## Product Change Notice

Date: August 2007

### 3M™ Universal Hot Melt Kits 6361 and 6365

FC Holders    SC Holders    ST Holders

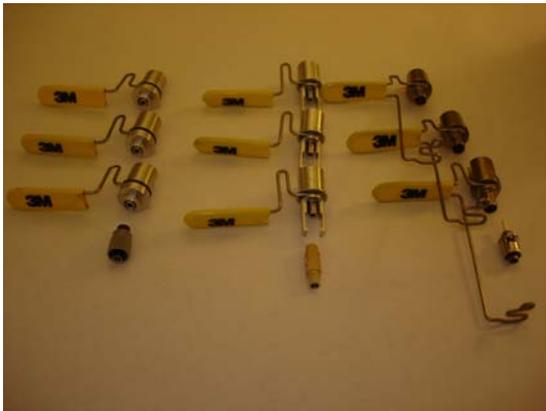
Over the last year, these 2 kits have had the following hot melt holders packaged within the kit. These included 3 each of the FC, SC, and ST style holders. These holders are used to place the connector within the oven for heating of the hot melt adhesive during termination of optical fiber.

Effective with this notice, these parts will no longer be packaged in the Universal Hot Melt Kits 6361 and 6365. The kits will now be packed with the new 3M Universal Hot Melt Holder 6365-HH ST SC FC 4-PACK. There is no price change to the kits.

The new 3M™ Universal Hot Melt Holder 6365-HH will accommodate all three FC, SC, and ST hot melt connectors. The universal holder is designed with a reversible barrel load adaptor that can be removed and re-inserted into the heat resistant handle. The longer end of the load adaptor accepts the FC and SC connector; the shorter end accepts the ST connector, as shown in the photo below. Four holders are now supplied with each kit. When ordered separately, the 4-pack is a bubble pack tray of 4 holders.
